Revision 2 notes:
- Corrected capacitor footprint sizes:
  - C2, C5 0805 -> 1210
  - C4 0805 -> 1206

Sheet: /
File: treble-booster.sch

Title: Treble Booster Pedal

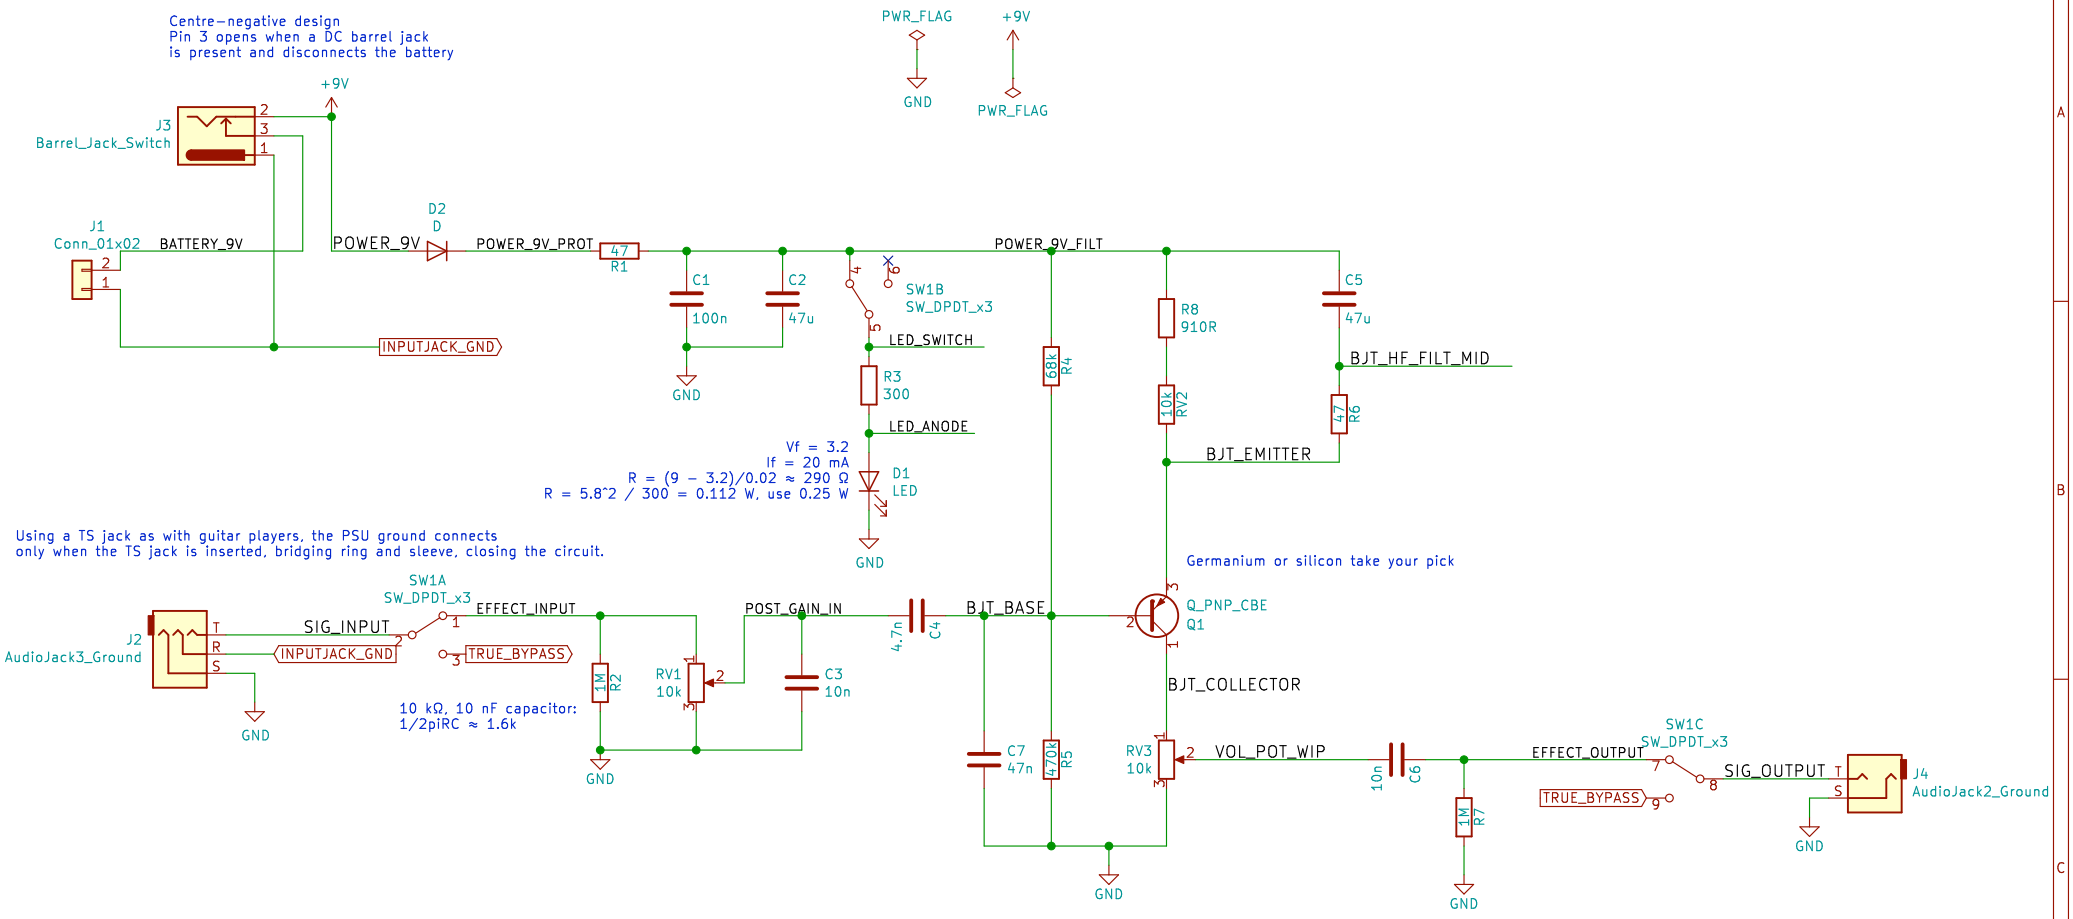
Boost LED resistor power handling
- R3 0.1W -> 0.25W
- R3 3k -> 180 Ω

Added dedicated 9V battery snap J1

Added switching DC barrel jack J3 which disconnects battery

Used ring of J2 audio jack to connect ground and enable device.

Added D2, dedicated reverse polarity diode

Added R8 as minimum resistance to prevent RV2 from burning out (precautionary, not likely).

Q1 package from narrow to wide.

C4 and C6 need to be both 0805 and 1210 to accomodate
C3 needs to be both 0805 and 1206
